Docket Item # 10  
BAR CASE #2009-0107

BAR Meeting  
June 17, 2009

**ISSUE:** Alterations  
**APPLICANT:** Deborah Dittmann  
**LOCATION:** 425 North Columbus Street  
**ZONE:** RM/Townhouse zone

The applicant is requesting approval of a Certificate of Appropriateness for replacement windows at 425 North Columbus Street.

Figure 8. Window specifications for front windows: double-glazed, true divided light.

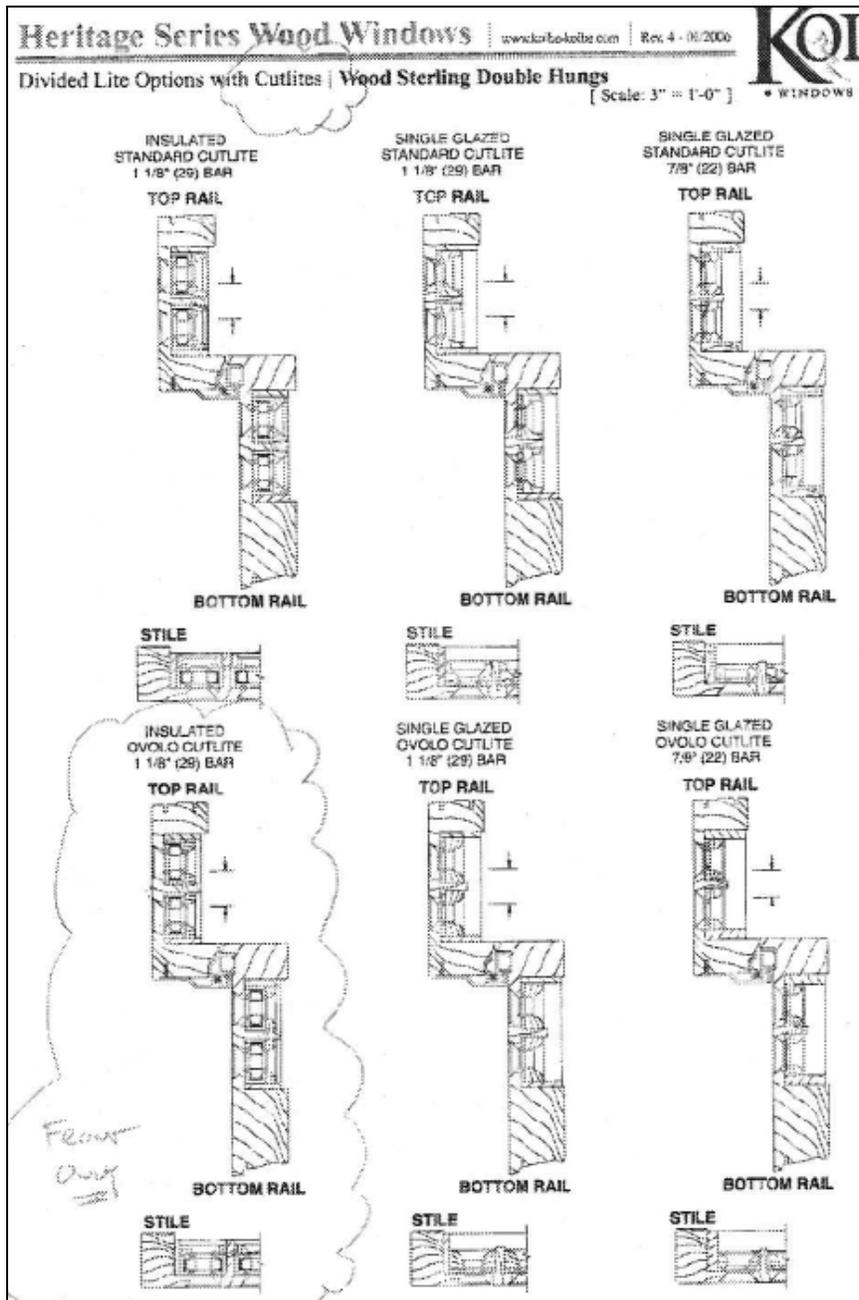
The existing windows are single-glazed, two-over-two wood windows with exterior storm windows. The windows appear to be original. The applicant is requesting approval of Kolbe and Kolbe Heritage Series Wood Windows. The proposed windows are two-over-two, double-glazed wood windows to match the existing windows. The windows on the front are proposed to be true divided light while windows on the side and rear are proposed to be simulated divided light windows with an interior spacer bar. The muntins will measure 1 1/8”.

The *Design Guidelines* recommend that: "...replacement windows should be appropriate to the historic period of the architectural style of the building." The *Guidelines* also state that single-glazed, true divided light windows with interior storm sash are the preferred replacement window type. The *Guidelines* continue by saying other acceptable window types are "double-glazed true divided light wood windows." In addition, the *Guidelines* note that "windows with fixed or applied muntins have been approved for the rear elevation of a structure which has minimal visibility from a public right of way."

Staff finds that the current submission request is not consistent with *Design Guidelines*. Should the applicant find the need to replace individual windows which are beyond repair on the side and rear elevations, Staff can administratively approve single or double glazed, true divided light wood windows for those windows.

**IV. STAFF RECOMMENDATION:** Staff recommends denial of the application as submitted.
